April 6, 2012

Cogentrix Quail Brush Generation Project – Docket Number 11-AFC-3, Data Request Responses to Set 2

Transmission System Engineering

Figure 1.1-1 Project Layout

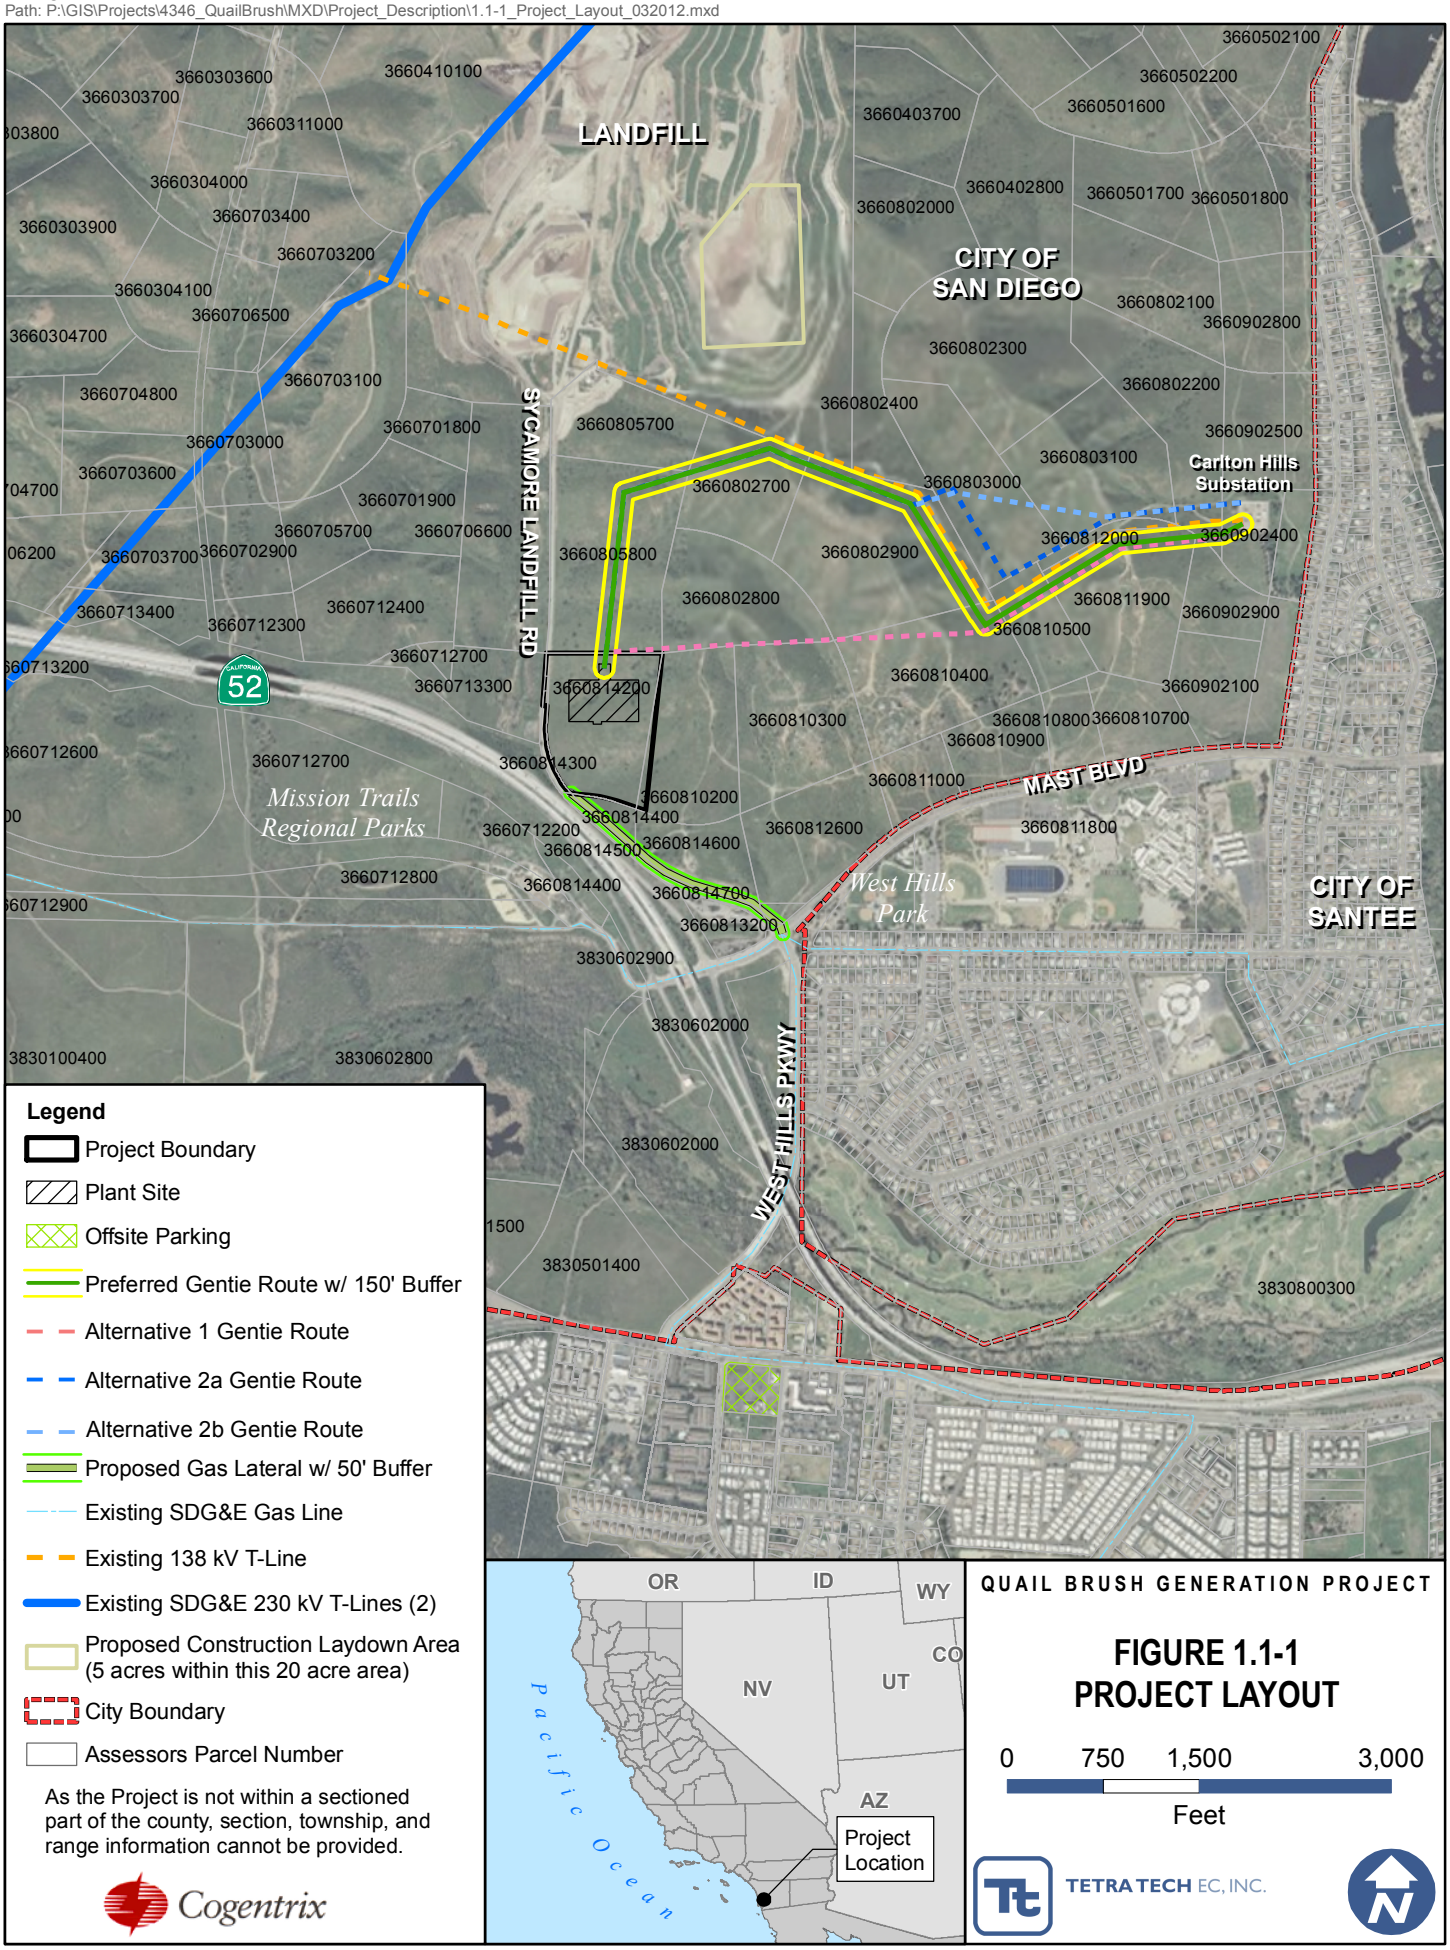
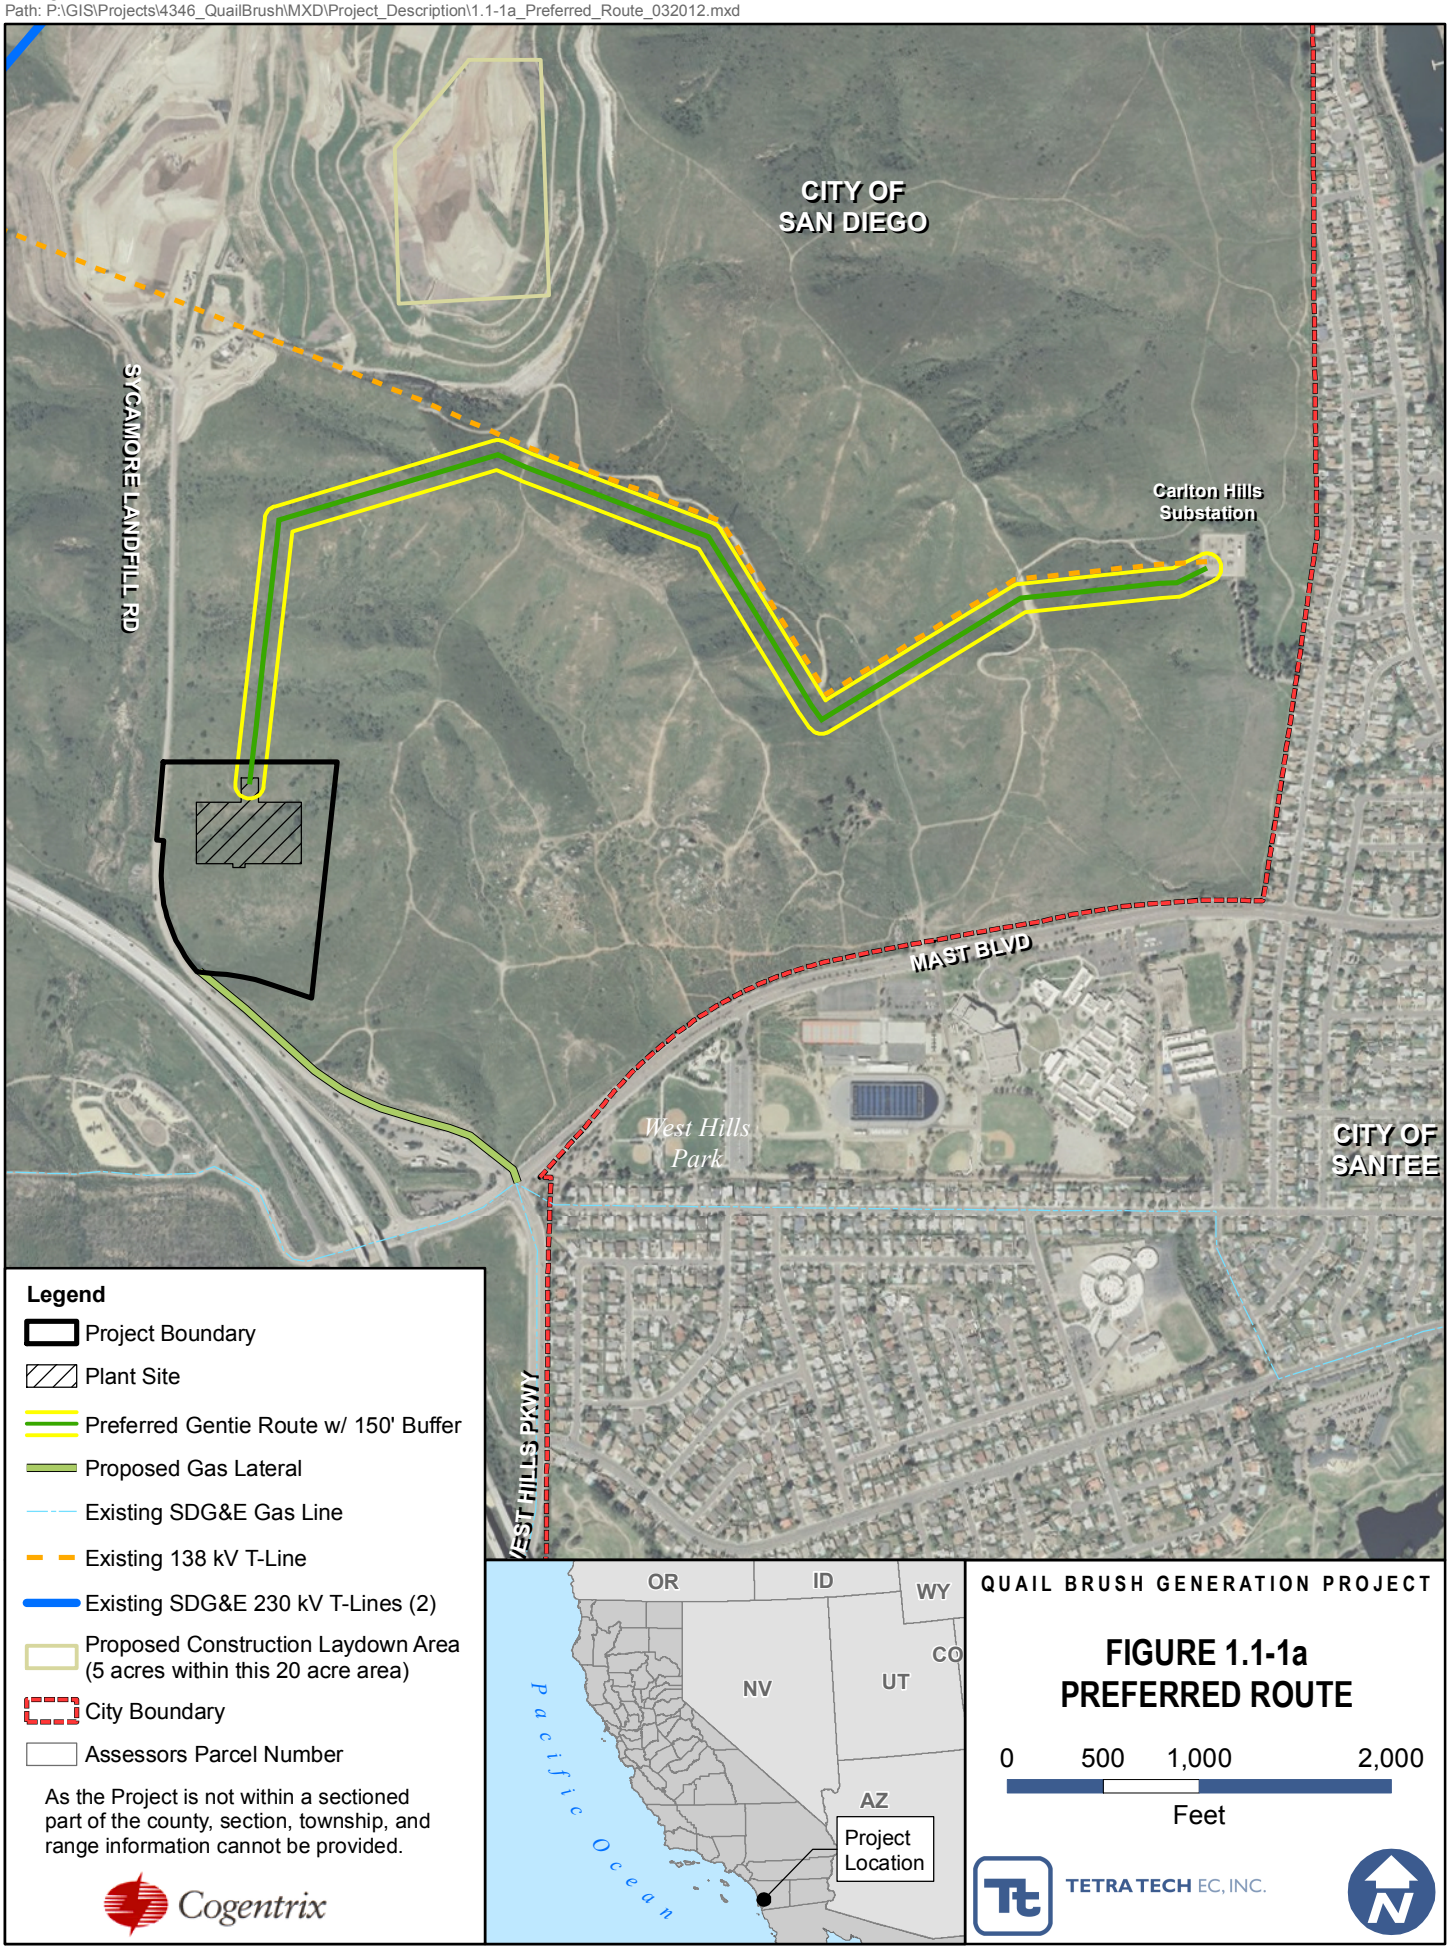
61. Please provide a discussion and drawing of the physical layout showing distinctly (in a larger scale) the preferred route (along any road or land or overhead line) of the proposed 6,850-foot long 138 kV overhead gen tie line including Right of Way (ROW) width(s) between the proposed QBGP 138 kV switchyard and the SDG&E 138 kV Carlton Hills substation. Describe whether the ROW would be through private and/or public lands.

As indicated on Figure 1.1-1 "Project Layout" of Supplement 2 to the AFC docketed February 8, 2012, Quail Brush proposed 4 gen tie routes labeled as Preferred, Alternative 1, Alternative 2, and Alternative 3.

Quail Brush is currently focused on three gen tie routes. The routes are denoted as Preferred, Alternative 2a, and Alternative 2b and depicted on the attached Figure 1.1-1 "Project Layout". After running north/northeast from the QBGP switchyard for approximately 1,350 feet, the Preferred route runs immediately south of the existing SDG&E 138 kV line and parallels this line to the Carlton Hills Substation (Figure 1.1-1a). The Alternative 2a route crosses the existing SDG&E 138 kV line and parallels the line on the north to the Carlton Hills Substation. The Alternative 2b route also crosses the existing SDG&E 138 kV line, but then takes a more direct route into the Carlton Hills Substation as shown on Figure 1.1-1. The Preferred route will terminate on the empty south bay of the Carlton Hills Substation presently depicted on the SDG&E drawings labeled "After Quail Brush" included in Attachment K. Alternative 2a or 2b routes will terminate on the empty north bay of the

In all cases the proposed Quail Brush gen tie right-of-way (ROW) width is 150 feet and runs entirely on private land.

QUAIL BRUSH
KEY ONE-LINE DIAGRAM

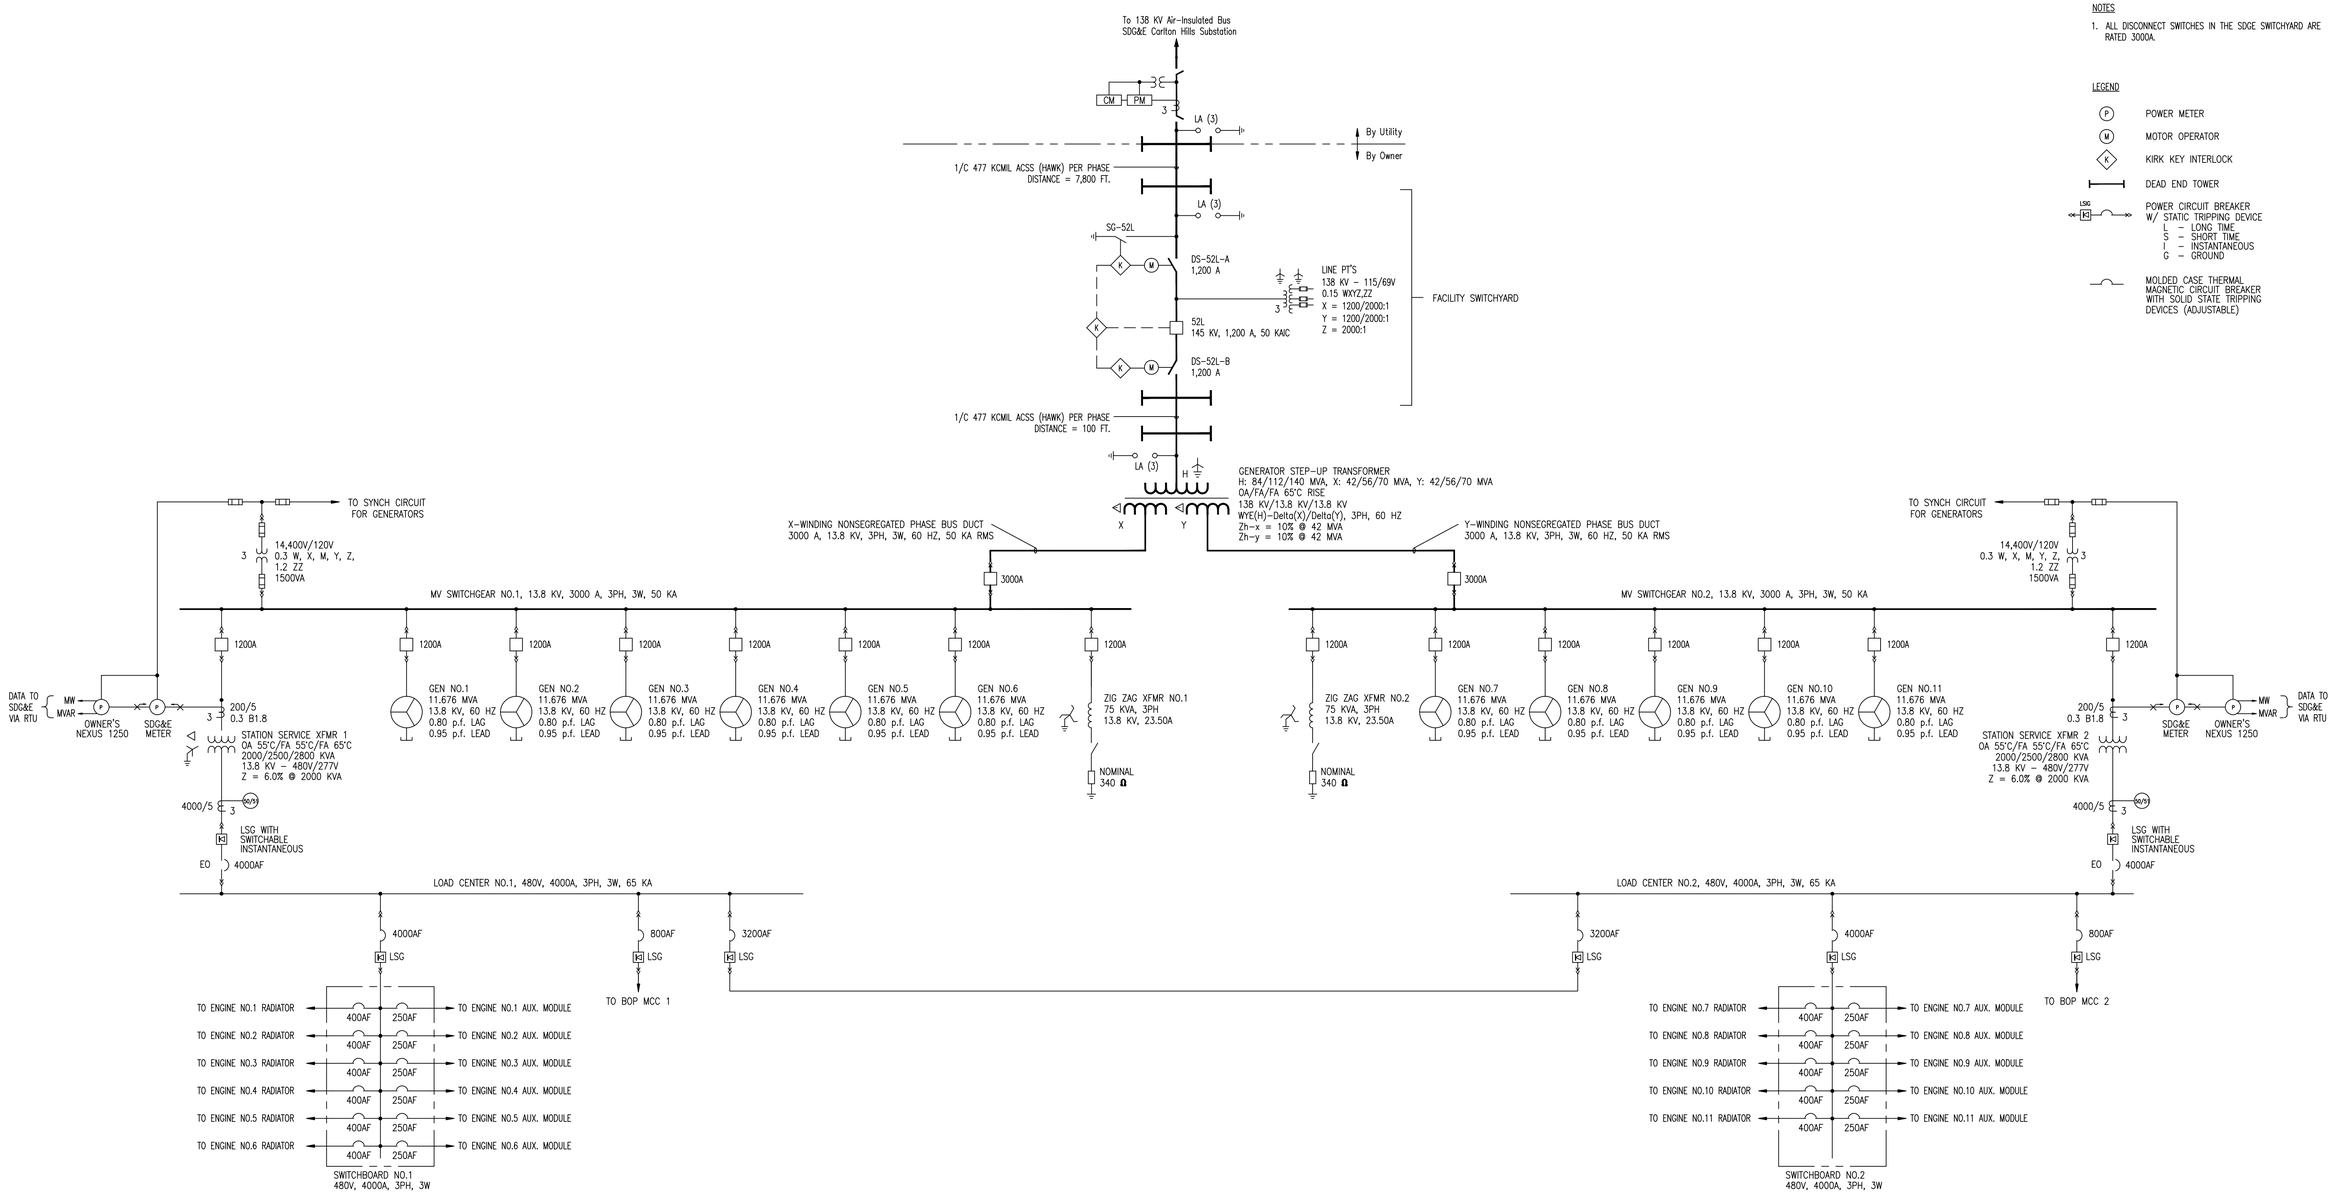
59. Provide a complete electrical one-line diagram (or resubmit Exhibit 4 with amended size/ratings of the applicable equipment and/or missing elements) of the proposed QBGP 138/13.8 kV switchyard showing all equipment for all eleven generator units' interconnection with the switchyard with their respective sizes and/or ratings as follows: i) Any bus duct connectors or overhead conductors or cables, 13.8/15 kV switch gear, buses, breakers & disconnect switches on the low side of generator step-up transformer (GSU). ii) The GSU and short overhead conductors/cables from the GSU high side to the switchyard 138 kV bus with the configuration of the switchyard 138 kV buses, breakers, disconnect switches, along with the proposed generator (gen) tie line transmission outlet.

Drawing QBPP-E001 Rev. E "Quail Brush Key One-Line Diagram" is attached as Attachment A.

Quail Brush
Switchyard Layout

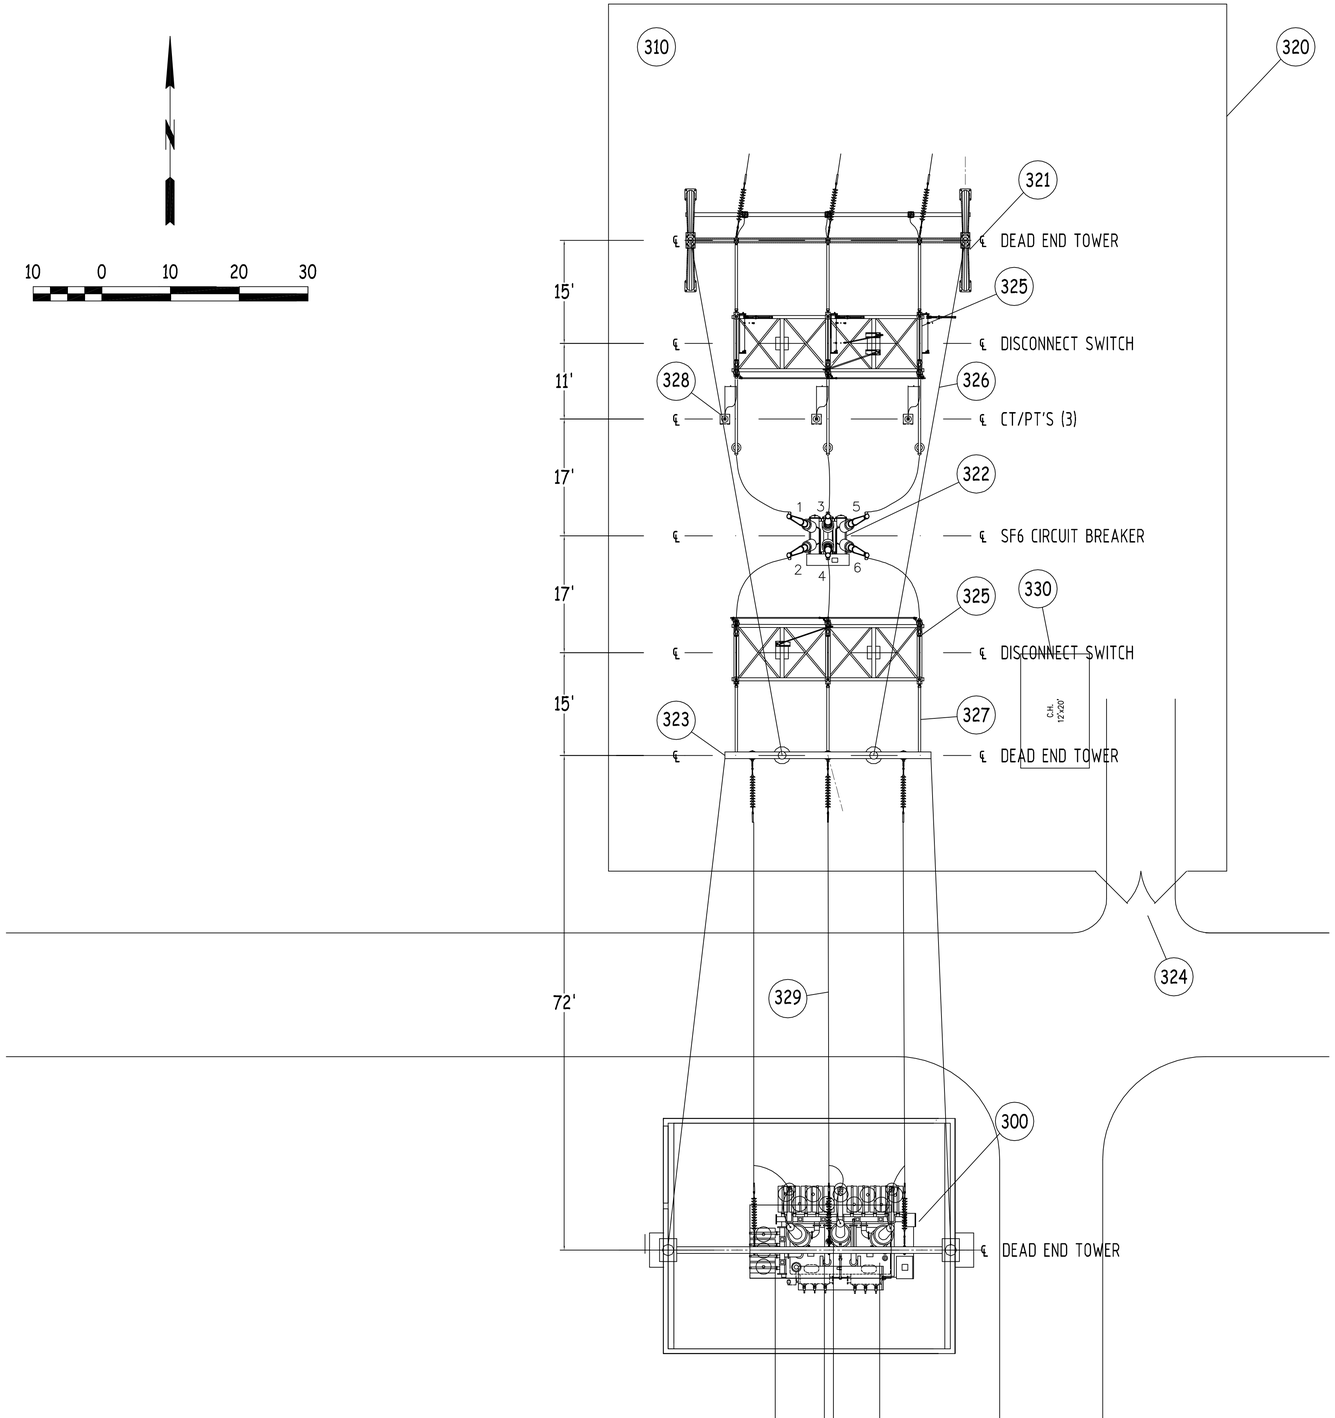
60. Provide a physical layout drawing of the QBGP 138/13.8 kV switchyard showing all major equipment (generators, buses, transformers, breakers and disconnect switches etc.) and transmission line outlet(s).

Drawing QB-SP-3 Rev. A "Quail Brush Switchyard Layout" is attached as Attachment B (based on the Site Plan included as Figure 2.3-1 from the AFC). A typical A frame structure is attached as Attachment C.
